**PARK CITY MUNICIPAL CORPORATION
 PLANNING COMMISSION
 CITY HALL, COUNCIL CHAMBERS
 JUNE 28, 2013**

Planning Commission Staff Report

Subject: Green Park - Cohousing
Authors: Francisco Astorga & Anya Grahn, Planners
Project Number(s): PL-13-01831 & PL-13-01832
Date: June 26, 2013
Type of Item: Work Session on Plat Amendment & Conditional Use Permit Applications

site analysis

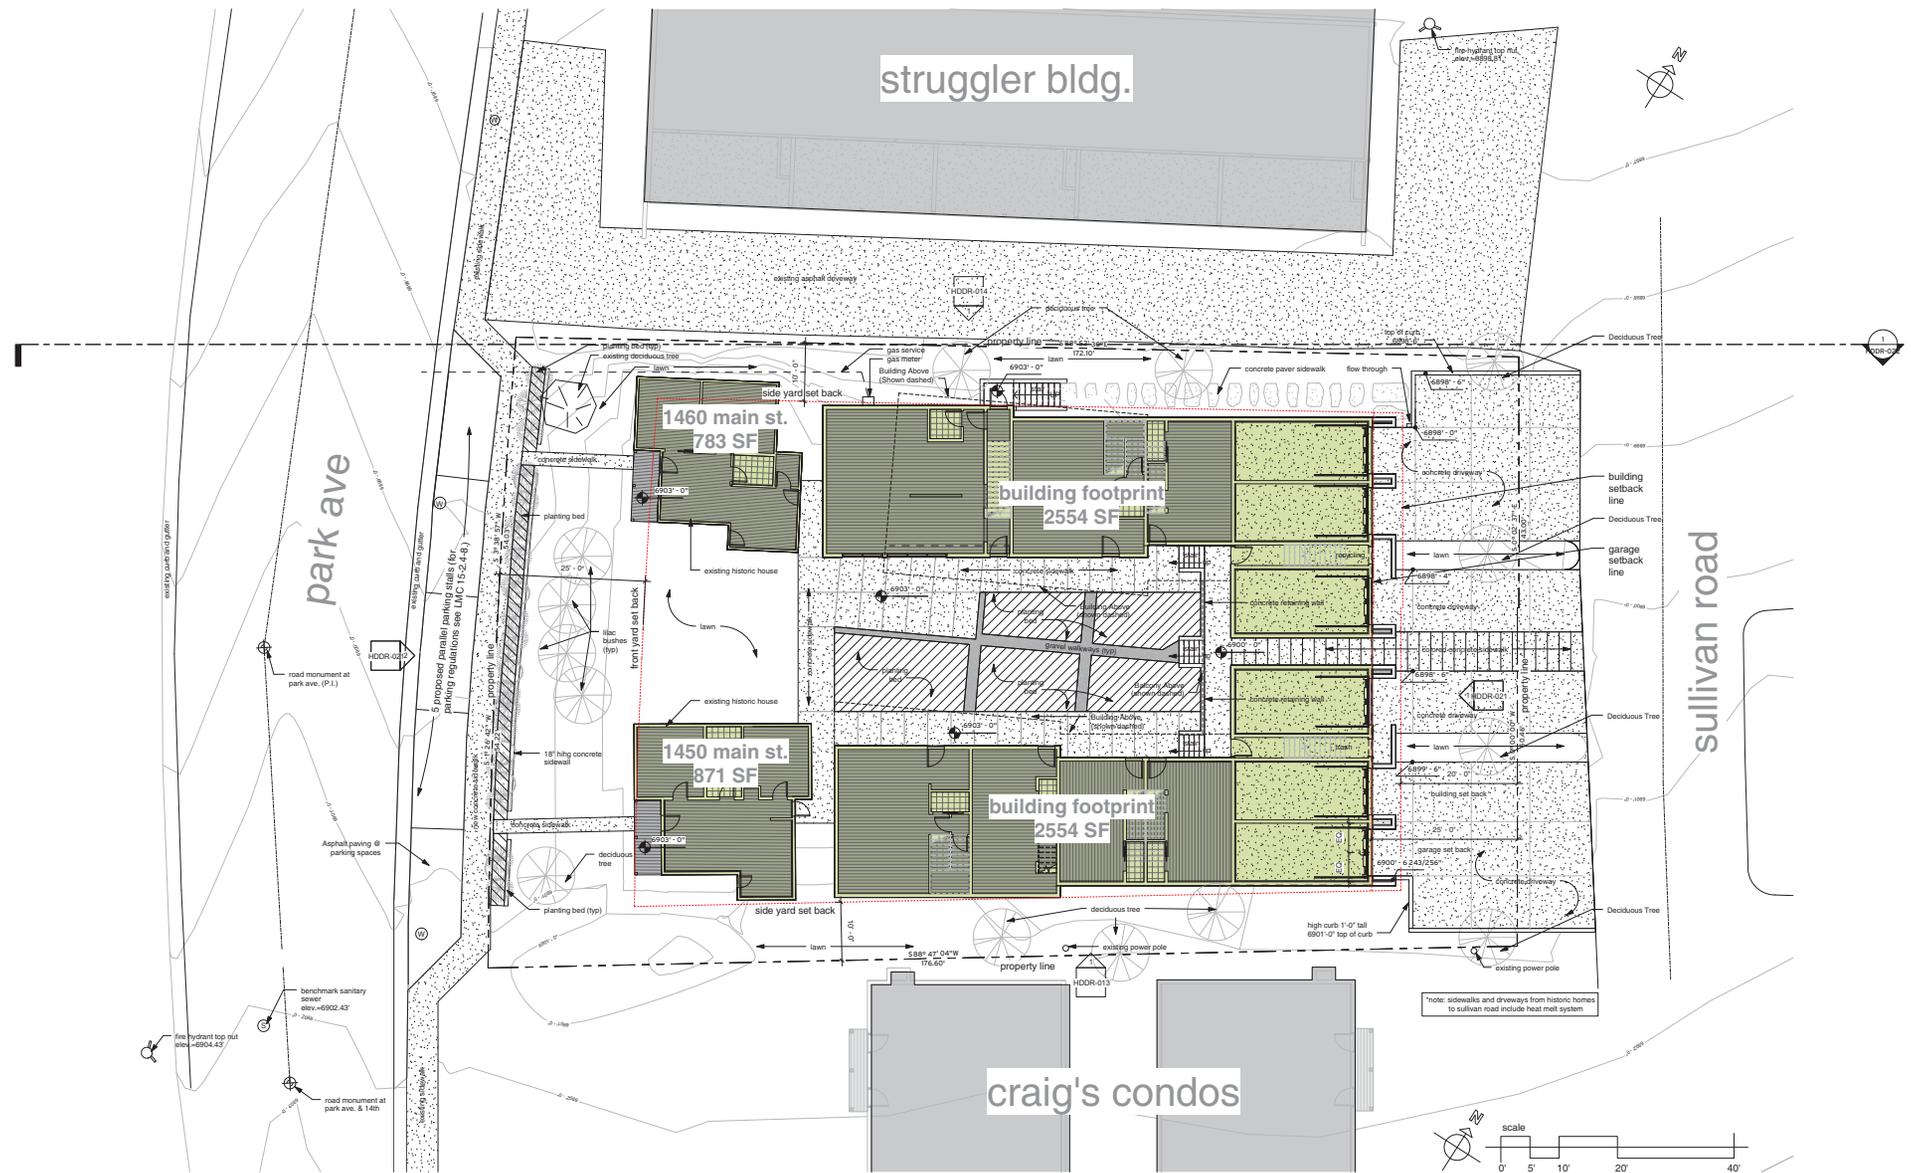
- D. The Applicant must provide Open Space equal to at least sixty percent (60%) of the total Site for Multi-Unit Dwellings. [...] Parking is prohibited within the Open Space. See Section 15-15 Open Space. **Discussion requested.**

There are no existing pedestrian connections or landscape elements along the streetscape, within the development site, or between Park Avenue and Sullivan Road. The proposal does not provide any pedestrian connections within the project between the two (2) roads.

5. Parking Mitigation.
Plans that keep the Front Yard Setbacks clear of parking and minimize parking impacts near intensive Uses on Sullivan Road are positive elements of any Site plan. **Does not comply.**

dwelling unit area analysis

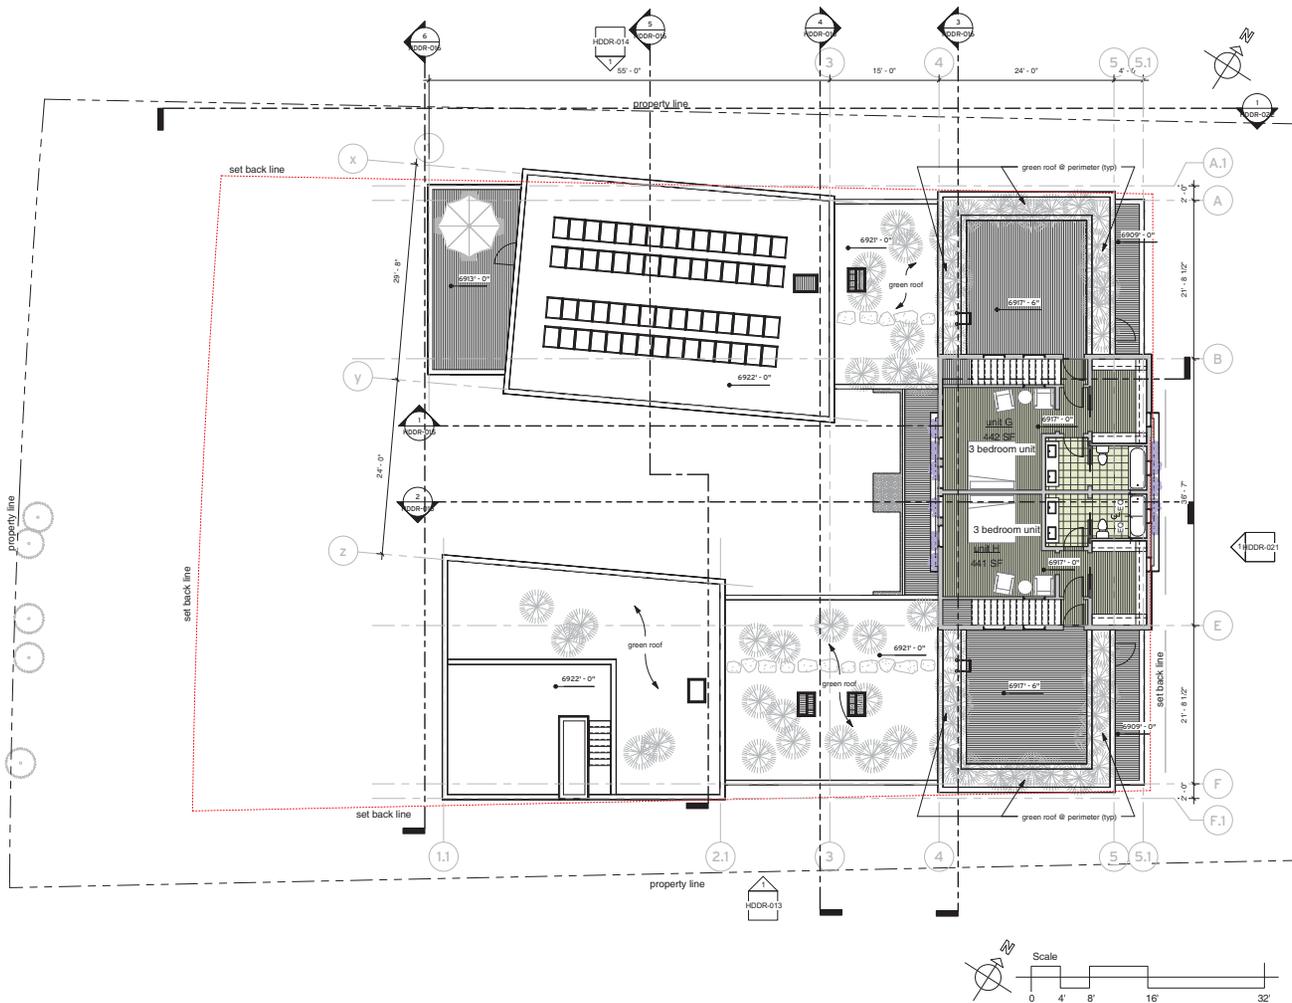
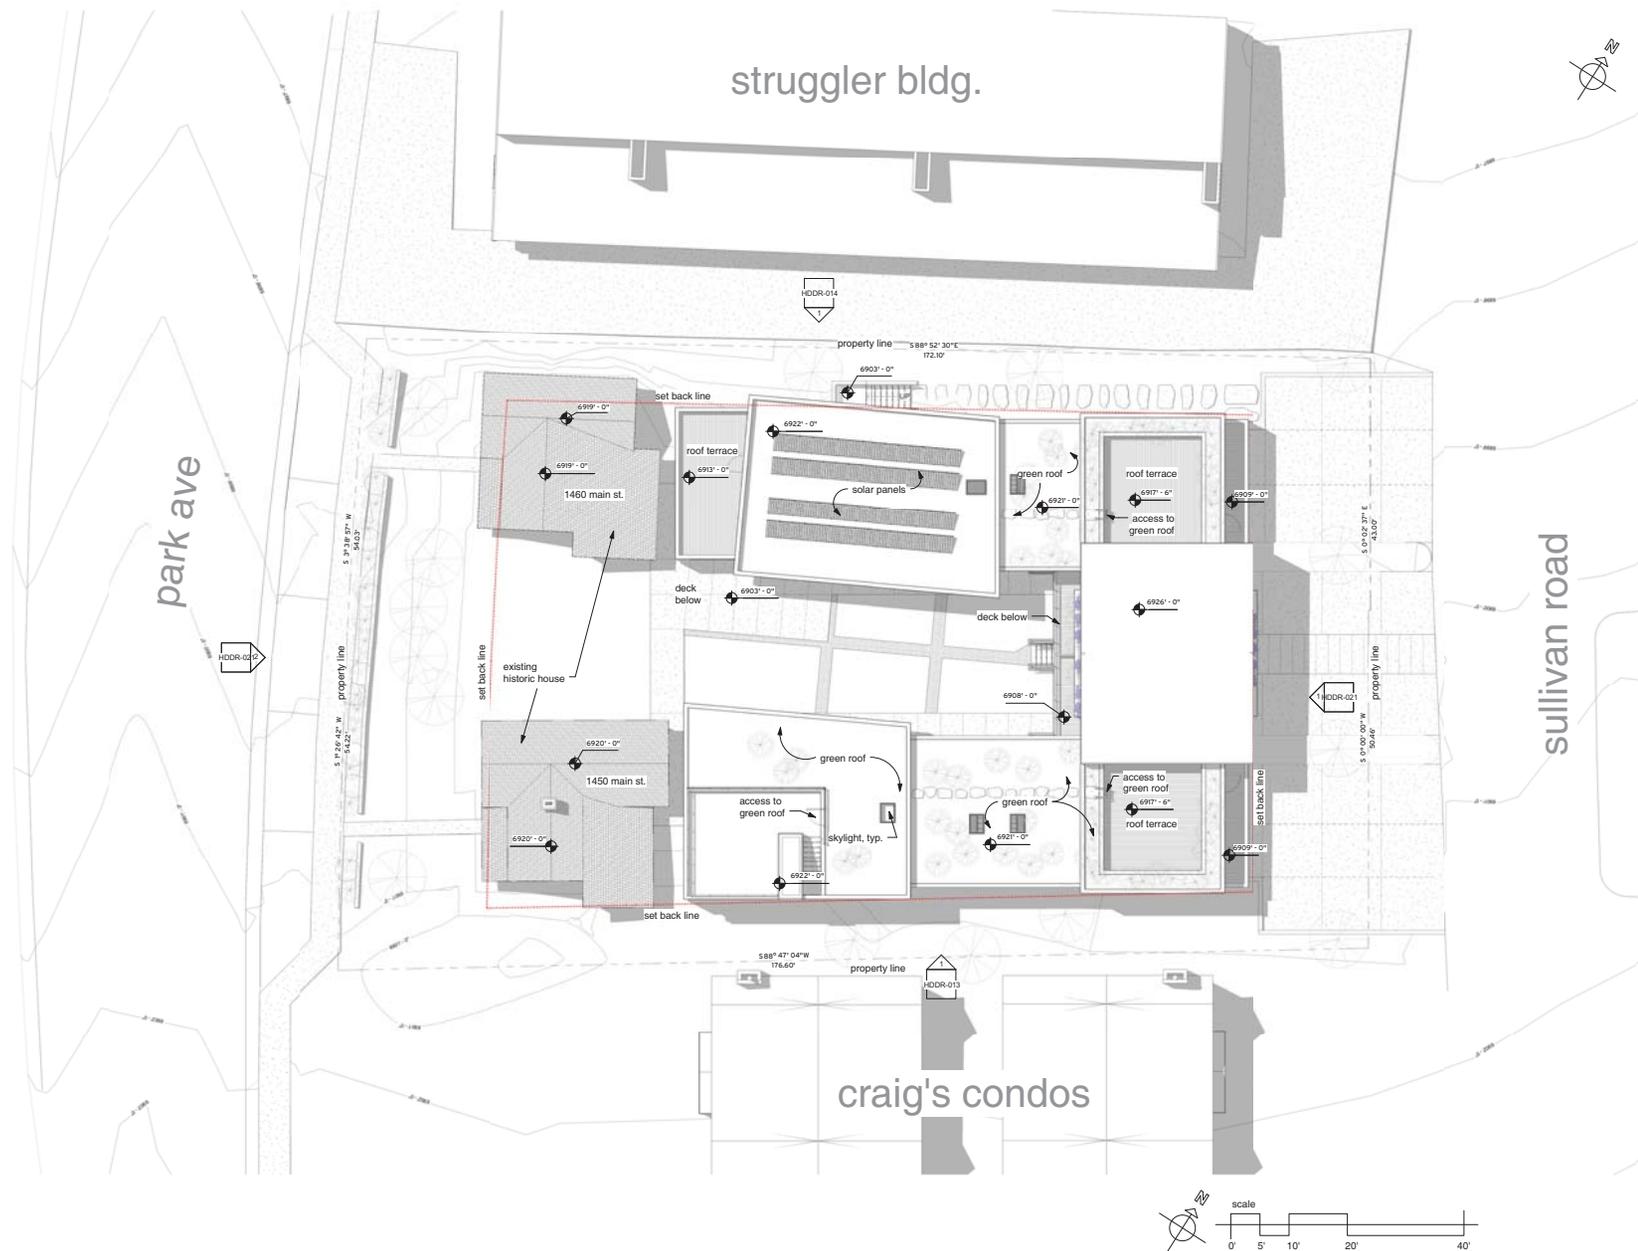
The applicant intends to provide six (6) garage parking spaces at the rear of the property, facing Sullivan Road. An additional eight (8) parking/driveway spaces will be provided in tandem configuration to the garages. Two (2) landscape grass strips will be provided to break up the four driveways/parking areas.

The proposed parking layout requires that the vehicles back up onto the public roadway, Sullivan Road. Sullivan Road is not considered by the City Engineer a public street. It's considered an internal road for City Park and that is why there are additional restrictions on using it for access outlined in Section V of this staff report. The applicant may submit a traffic and or engineer report/study that may show mitigate this provision in the LMC.

Parking designs, which necessitate parking one (1) vehicle directly behind another, not perpendicular to each other, are permitted only for Single Family Dwellings, Accessory Apartments, and Duplex Dwellings in all zoning districts. In any Zoning District where the Front Yard is twenty feet (20') or less, both Parking Spaces must be perpendicular to the Street, unless there is an adequate landscaped buffer between the Street and Parking pad, subject to review by the Planning Director.
